### Sample / Benchmark / Mock Up Record

Kings Cross Bridge 2 – GDR 594					
Document Ref. & Rev.	Package Description	Company Name			
KXC-GDR-BR2-XX-SA-W-0007	Hard Landscaping	Maylim			
Sample / Benchmark / Mock Up: Delete as appropriate	Paving to bridge				
Date of Issue:	19 <sup>th</sup> March 2021

Kings Cross Bridge 2					
Document Ref. & Rev.	Package Description	Company Name			
KXC-GDR-BR2-XX-TS-W-0002 Rev 00	Movement Joint	Galldris			
Date of Issue:	19-01-2021

Kings Cross Bridge 2						
Document Ref. & Rev.	Package Description	Company Name				
KXC-GDR-BR2-XX-TS-W-0008 Rev 00	Bedding mortar – South pavement	Galldris				
Date of Issue:	06-05-2021

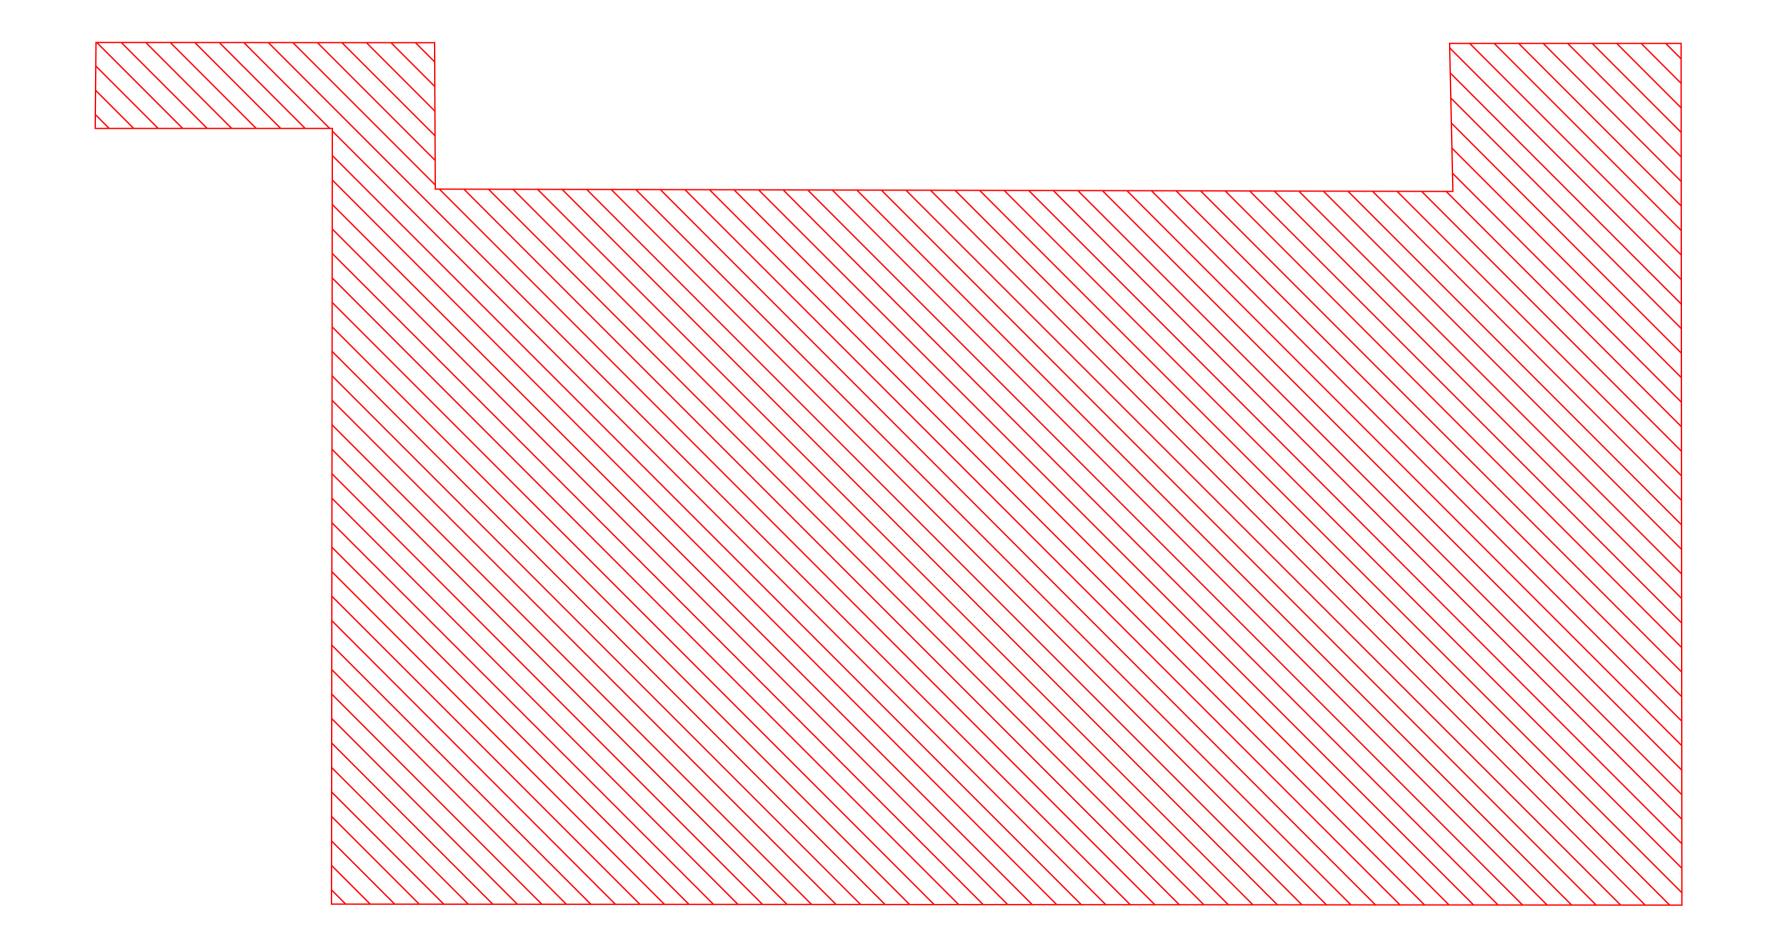
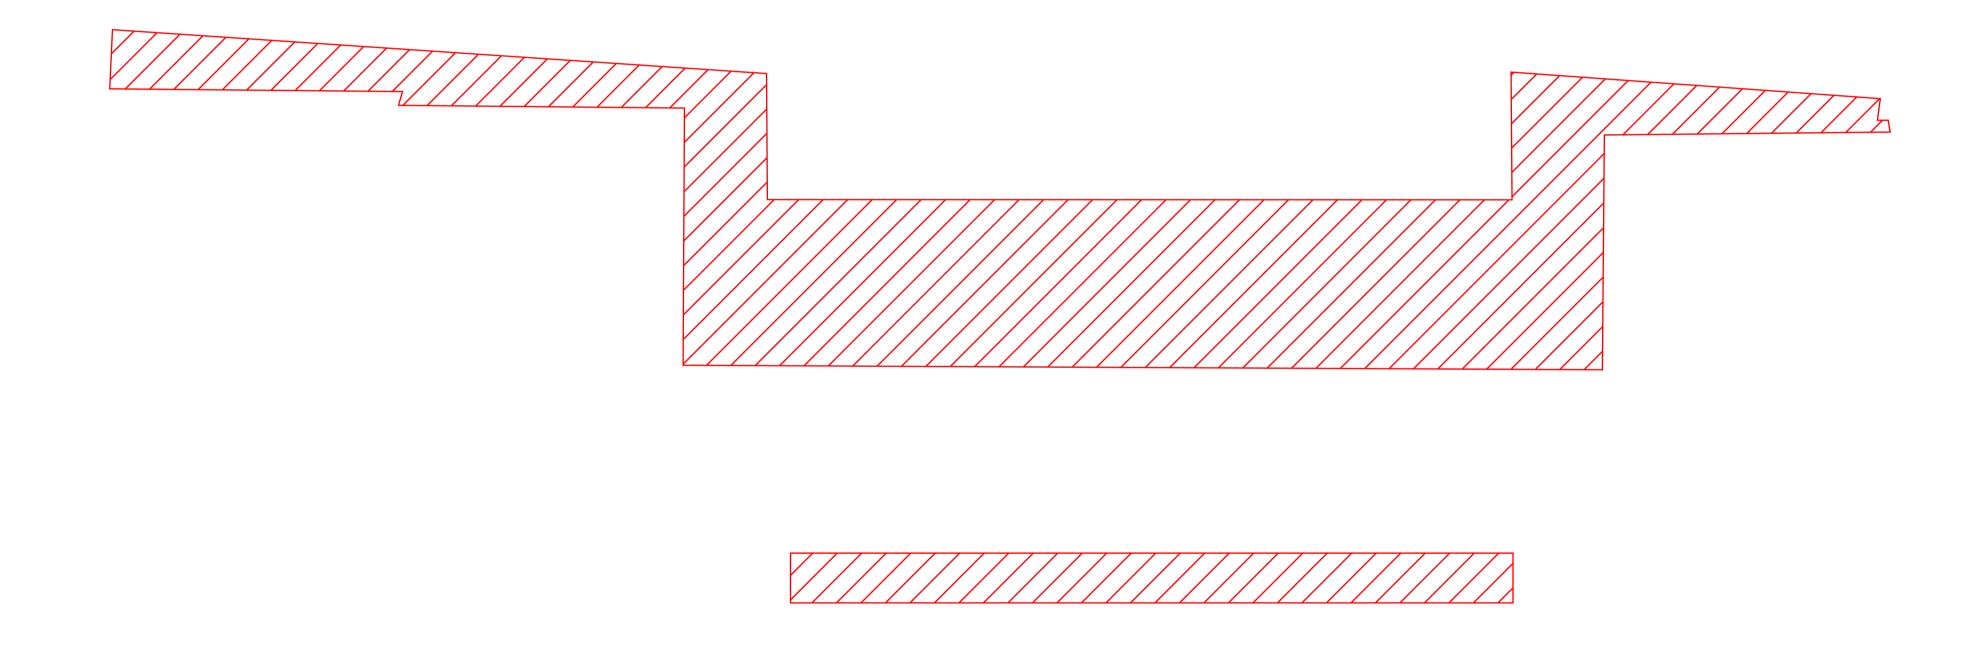
Extent of replacement brickwork hatched red

Extent of replacement brickwork hatched red
